33 CORINTHIAN ROAD
SO532AY

Proposed Elevations

Job No	Drawing No	Rev
COR33	PE01	B

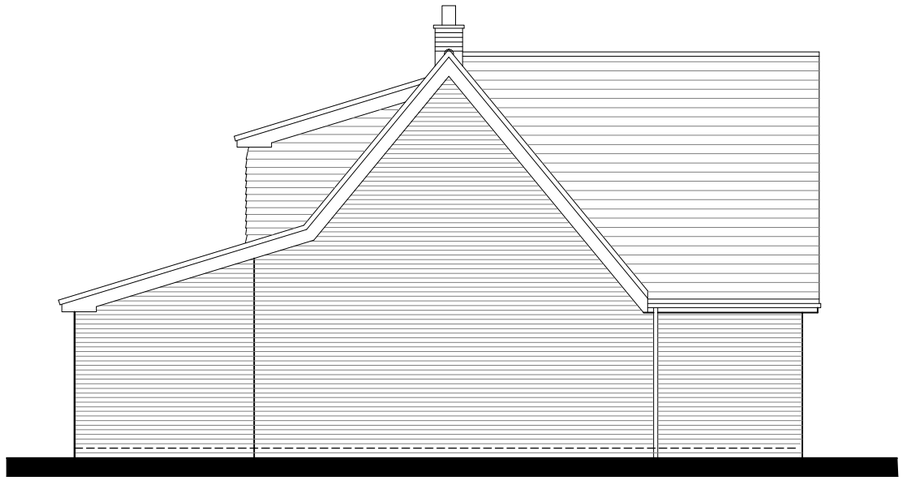
Rev	Amendments	Drn	Chk	App	Date
A	Gable proportion adjusted, side window added,	PC			06/15
B	first floor bathroom window width increased from 650mm to 1200mm small window on front elevation reduced in width 1200mm to 500mm Velux window removed from roof on rear elevation window and door handed on rear elevation	PC			05/16
